Addendum No. 1

Contract No.: DA00152

Rehab to Existing Emergency Ferry Ramp at Stumpy Point in Dare County.

DOLPHIN DETAILS
STUMPY POINT
FERRY BASIN

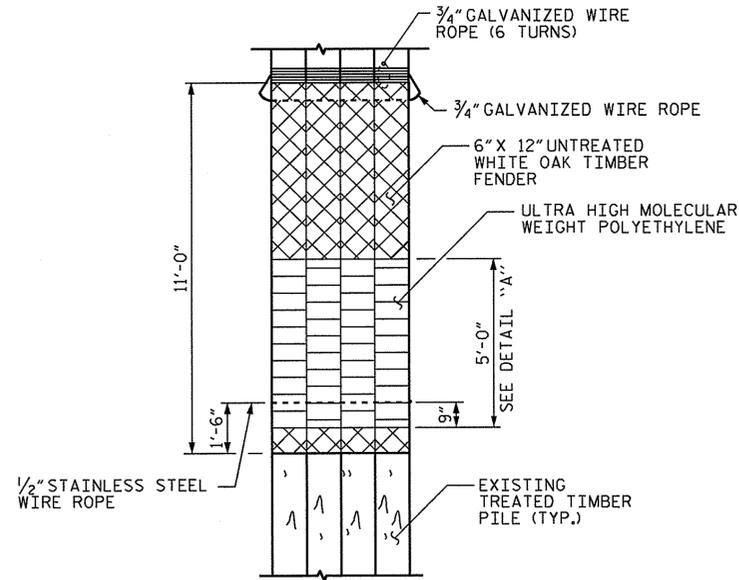
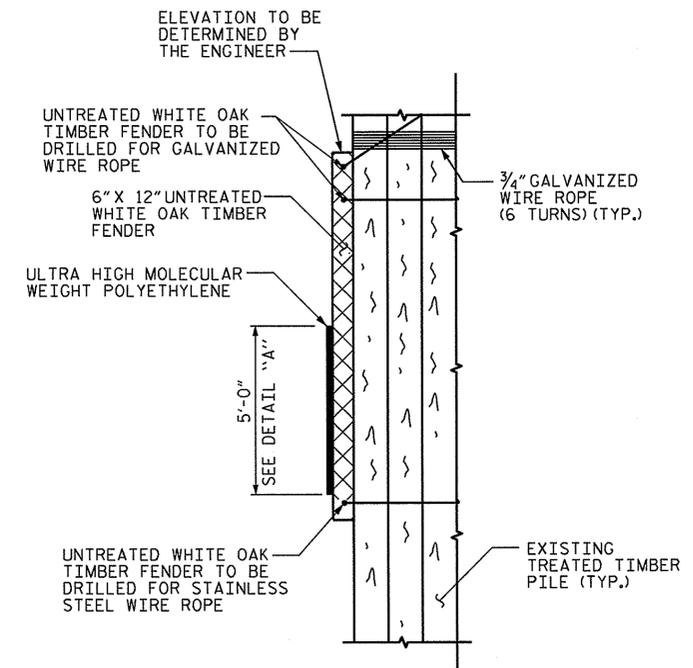
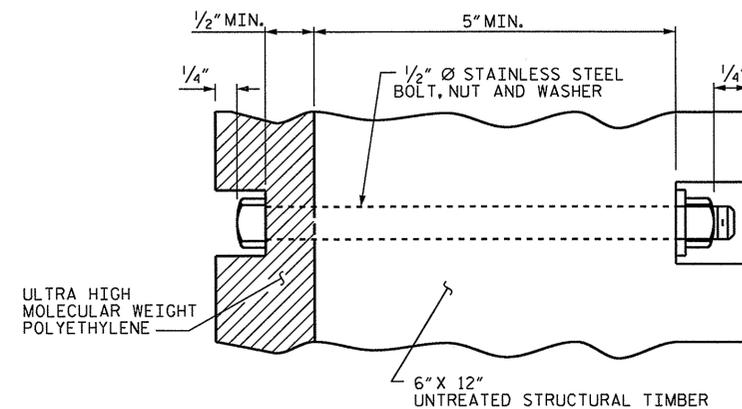
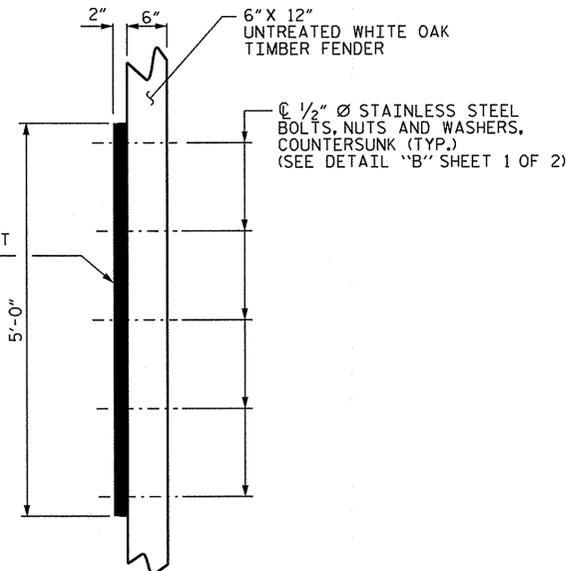
Plan Sheet S-11 & S-12 "Dolphin Details" has been revised to change the proposed $\frac{3}{4}$ " galvanized steel wire rope, located at the bottom portion of the dolphin, to $\frac{1}{2}$ " stainless steel wire rope. Please void the existing Plan Sheet S-11 & S-12 "Dolphin Details" in the proposal and staple revised Plan Sheet S-11 & S-12 "Dolphin Details" thereto.

STAINLESS STEEL WIRE ROPE USED FOR INSTALLING UNTREATED WHITE OAK TIMBER FENDERS SHALL CONFORM TO ASTM A368.

STATE OF NORTH CAROLINA DEPARTMENT OF TRANSPORTATION RALEIGH					
ELECTRICAL LAYOUT					
STUMPY POINT FERRY BASIN					
REVISIONS					
NO.	BY:	DATE:	NO.	BY:	DATE:
1	LVB	3/12/13	3		
2			4		
					SHEET NO.
					TOTAL SHEETS

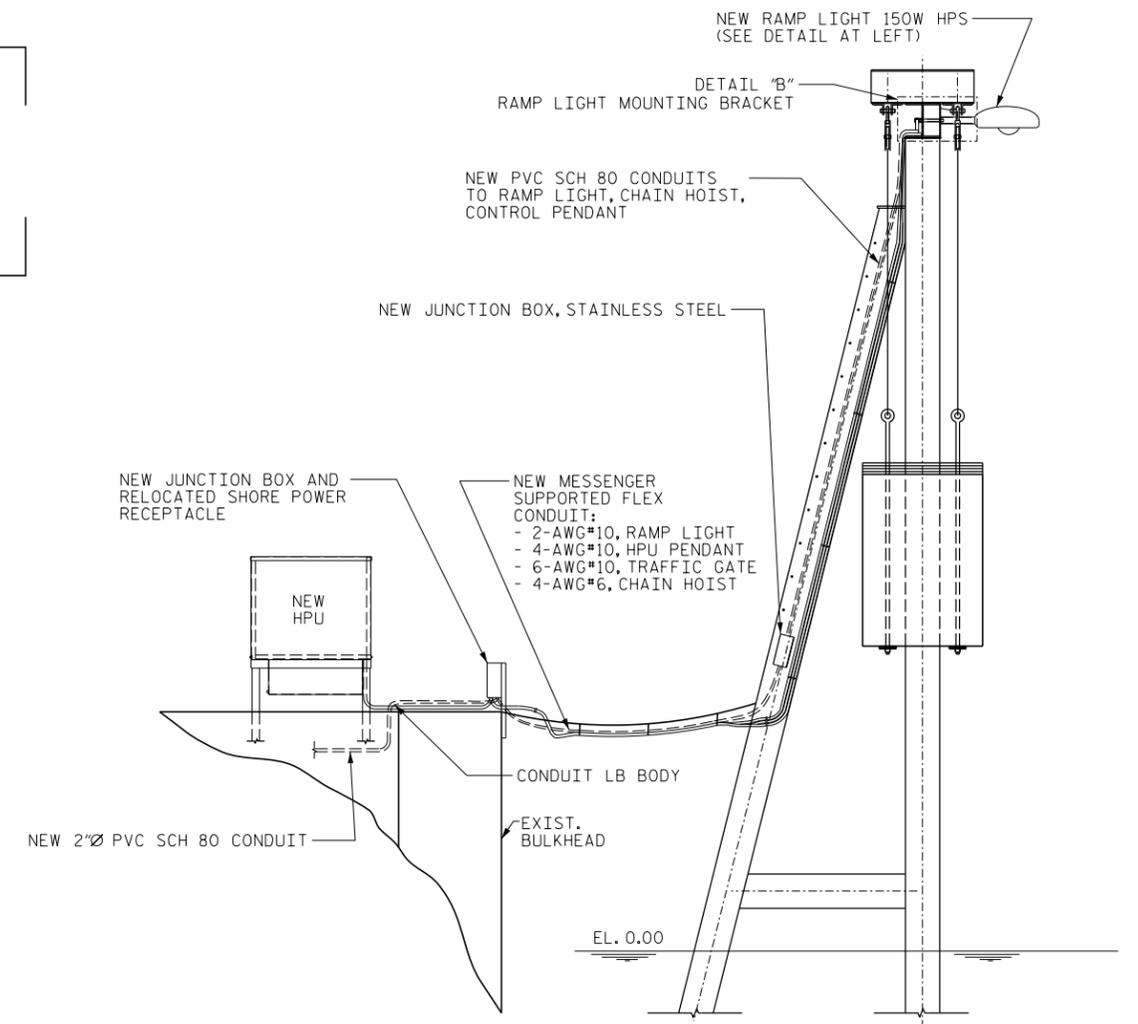
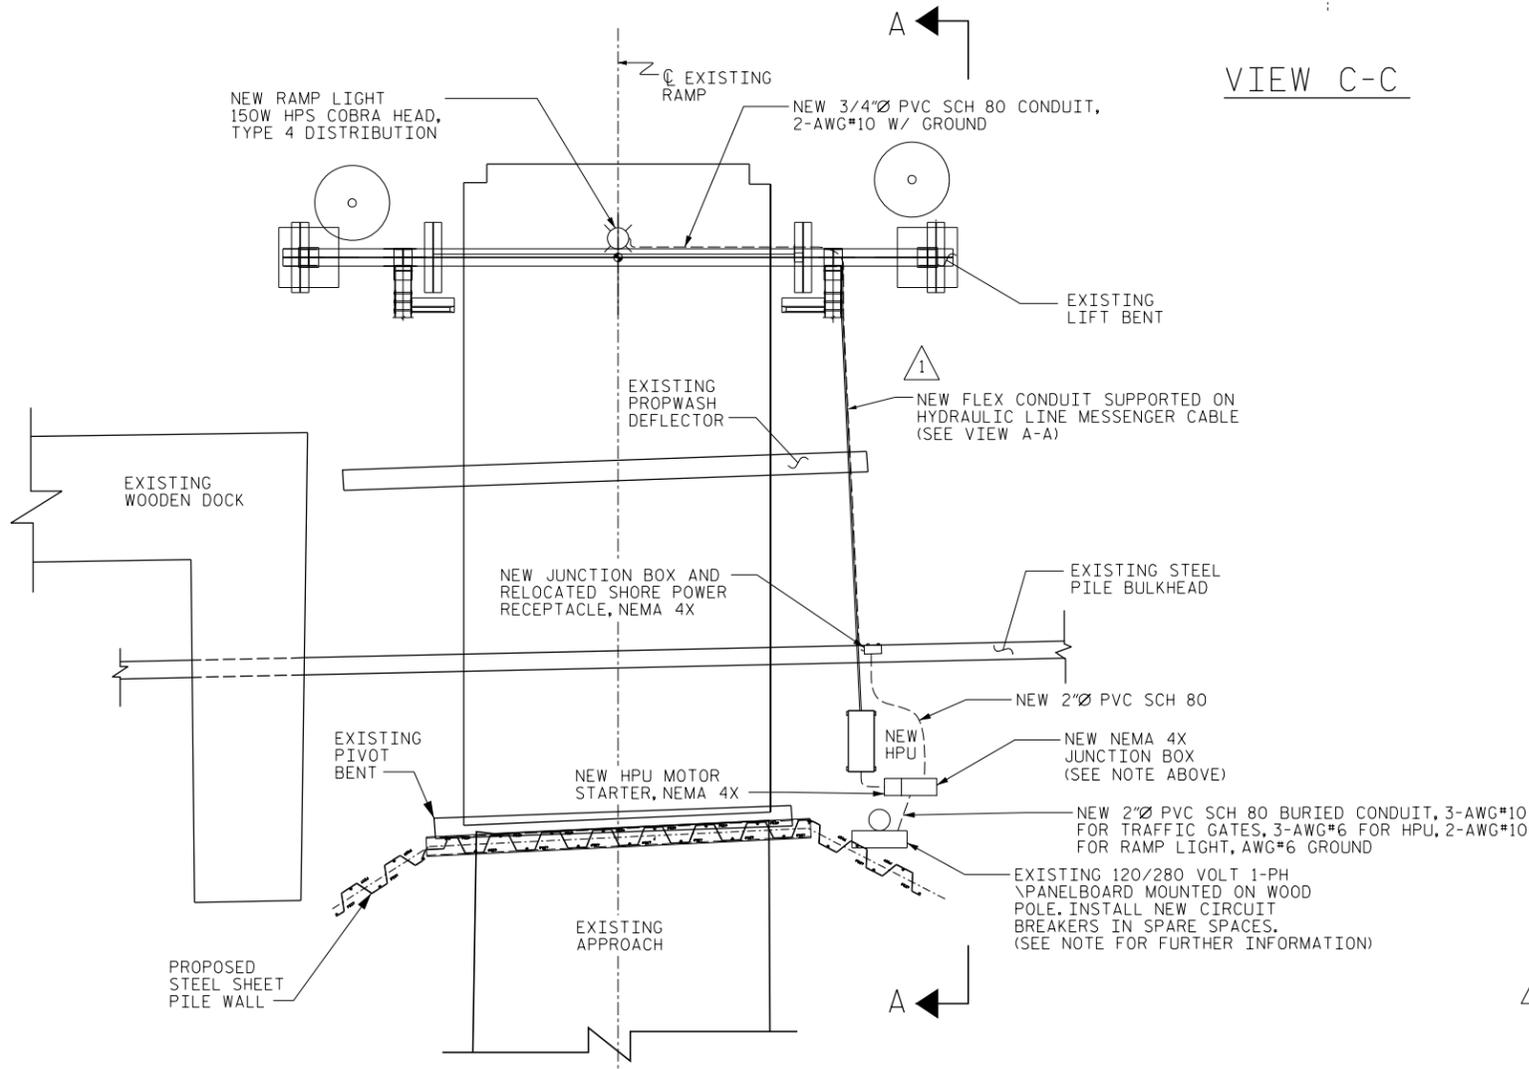
Plan Sheet "Electrical Layout" has been revised to clarify rigid conduit to be PVC and remove extraneous callout. Please void the existing Plan Sheet "Electrical Layout" in the proposal and staple revised Plan Sheet "Electrical Layout" thereto.

- 1 CLARIFIED RIGID CONDUIT TO BE PVC; REMOVED EXTRANEOUS CALLOUT.

CONTROL
PENDANT DETAILS

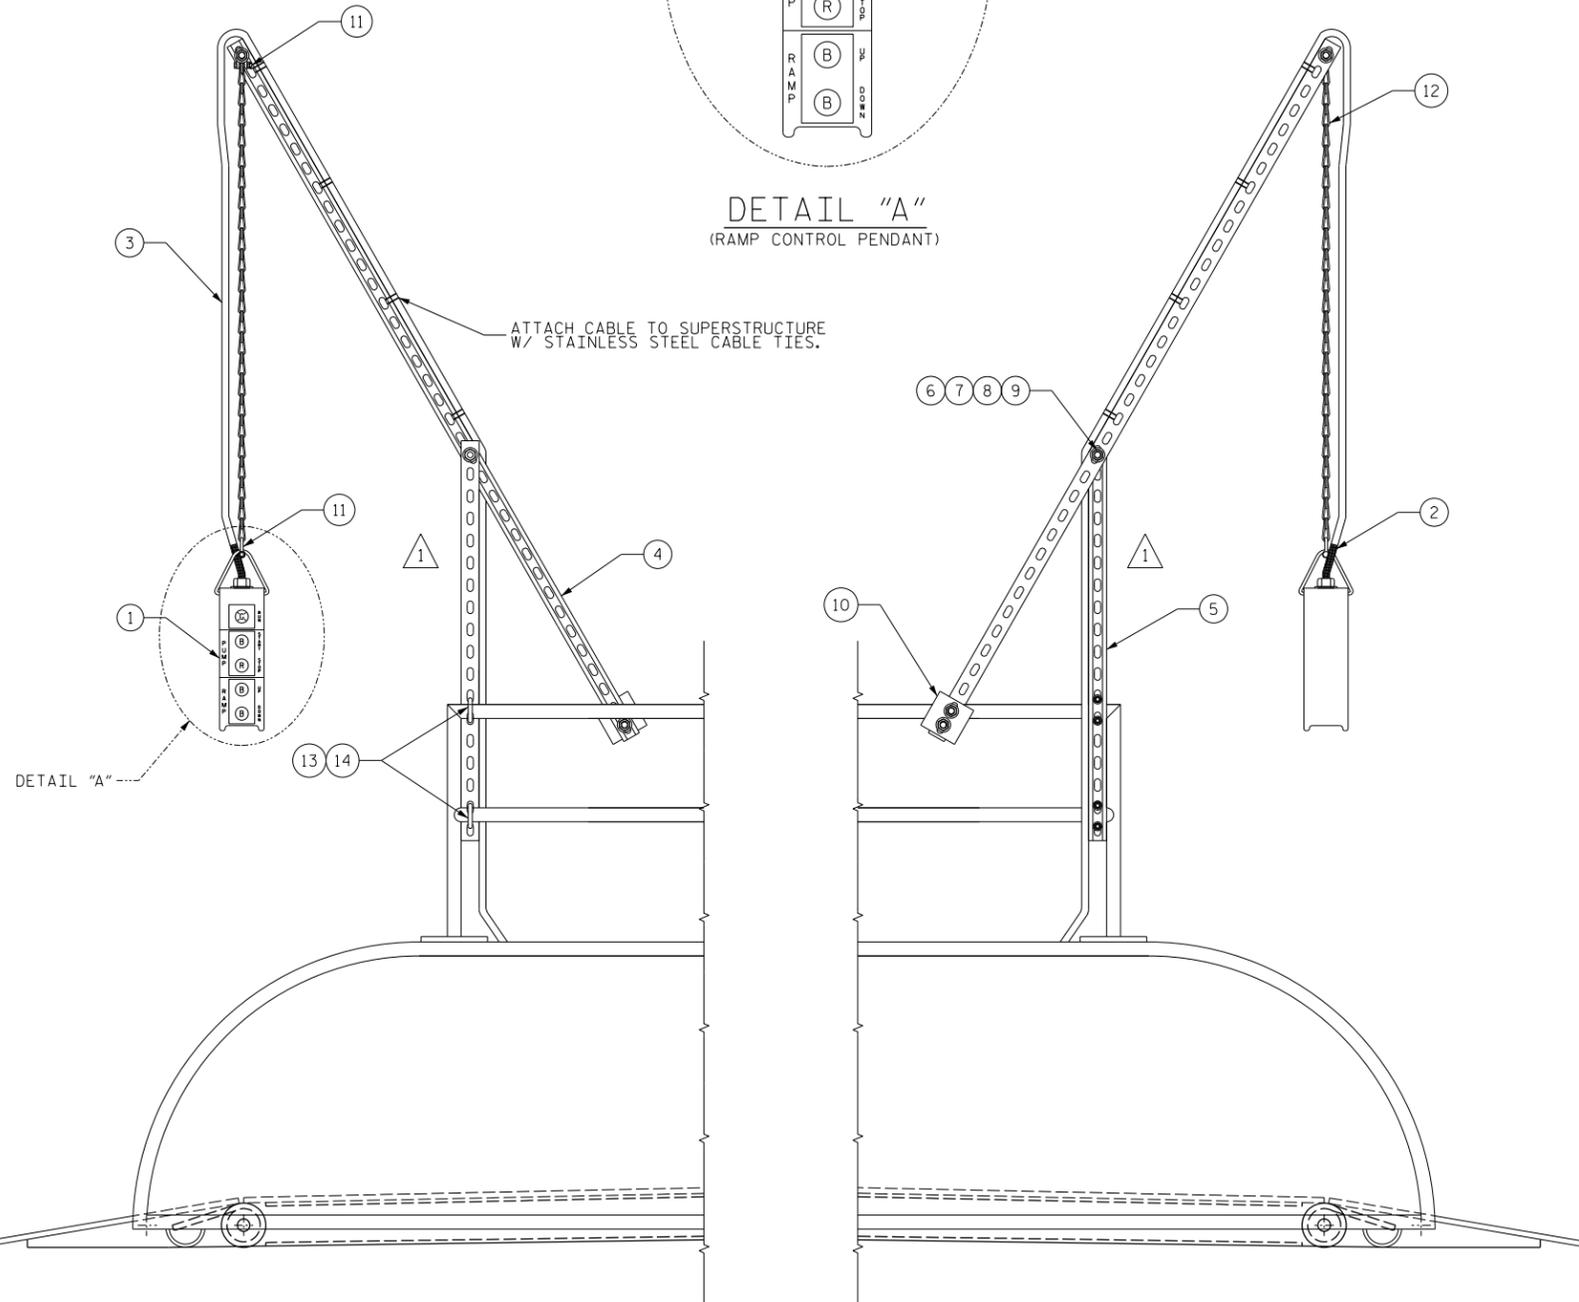
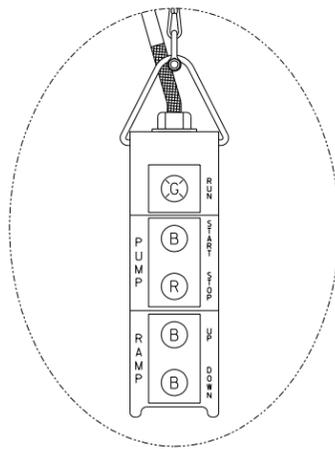
Plan Sheet "Control Pendant Detail" has been revised to eliminate the traffic gate control pendant. Please void the existing Plan Sheet "Control Pendant Detail" in the proposal and staple revised Plan Sheet "Control Pendant Detail" thereto.

- 1 REMOVED TRAFFIC GATE CONTROL PENDANT
